**NOTICE OF
SPECIAL MEETING OF THE TOWN COUNCIL
HICKORY CREEK TOWN HALL
1075 RONALD REAGAN AVENUE, HICKORY CREEK, TEXAS 75065
MONDAY, OCTOBER 05, 2026, 6:30 PM**

AGENDA ITEM: Consider and act on a site and landscape plans for Lennon II Addition, Lot 4, Block A, being 0.542 acres of land situated in the M.E.P. and P.R.R. Co. Survey, Abstract No. 915, Town of Hickory Creek, Denton County, Texas. The property location is 3150 FM 2181.

**Re: HTeaO Store #395 – 3080 FM 2181 (Lot 4, Block A – Lennon II Addition)
Site Plan and Landscape Plan
5th Review (3rd Review of revised submission)**

RE: HteaO Store 395 - Drainage Study in support of Final Plat (Lots 2A and 2B) and Site/Civil Plans for Lot 4 – 5th Review

C1.1A

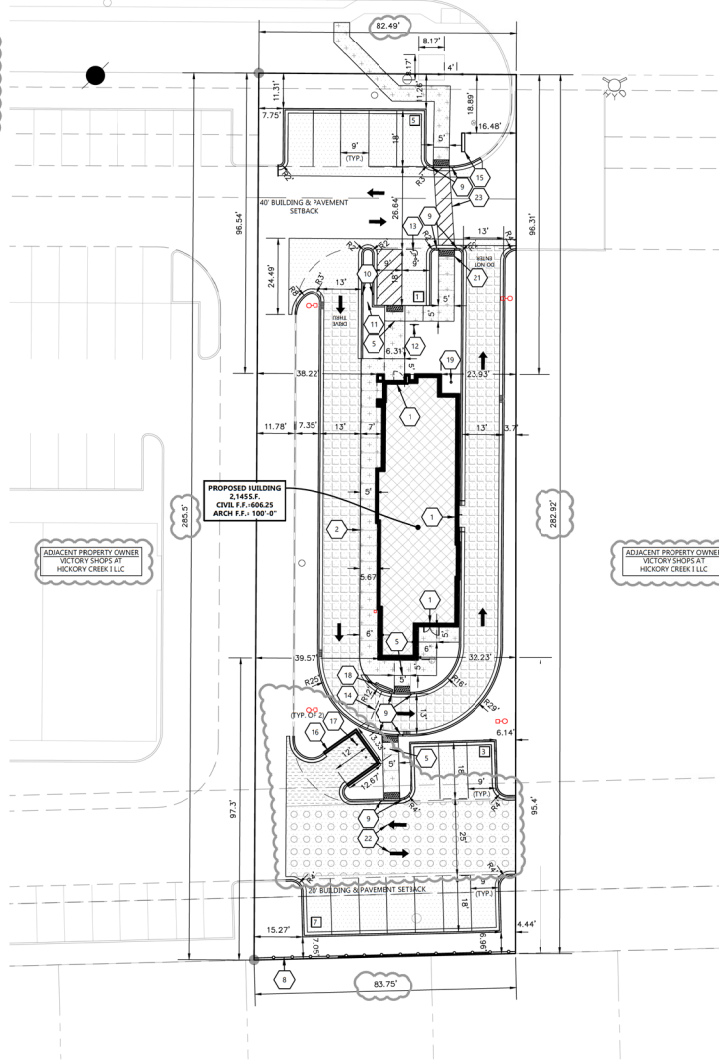
1. Please include lot dimensions on plan.
Comment addressed.
2. Please include the adjacent lot owner information.
Comment addressed.
3. Please include the FEMA Floodplain standard note, typically shown on platting.
Comment addressed.
4. Please include the "For Town Use" box
Comment addressed.

LS1.00

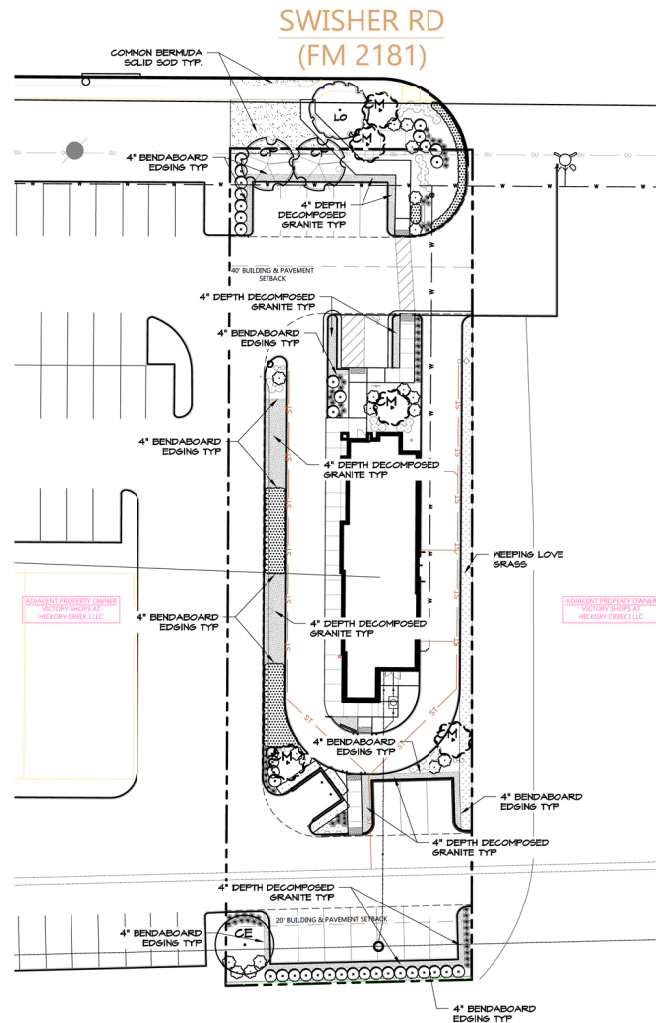
1. Please update title box of project information. It does not match Site plans.
Comment addressed.
2. Please add survey information, town and county and preparation date.
Comment addressed.
3. Please include the "For Town Use" box.
Comment addressed.

FINAL PLAT LOT 4, BLOCK A LENNON II ADDITION

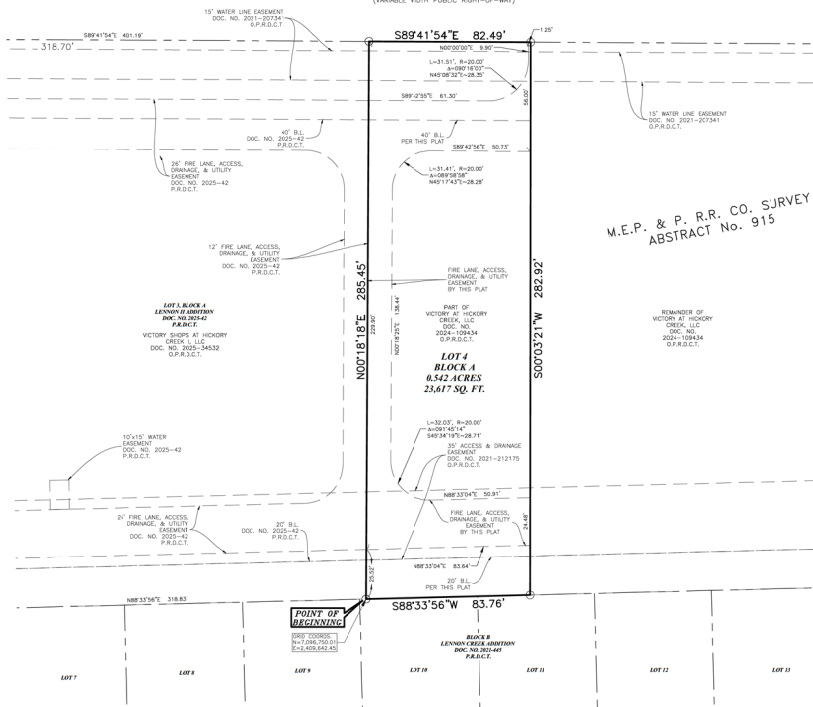
3. The final plat of Lots 2A and 2B does not match the preliminary plat. Please confirm a revised Preliminary Plat submittal is not required.
[1st Review Response: Noted.](#)

2nd Review Comment: FYI, the Town will require a revised prelim plat once the entire Block is built out and each lot is final platted.
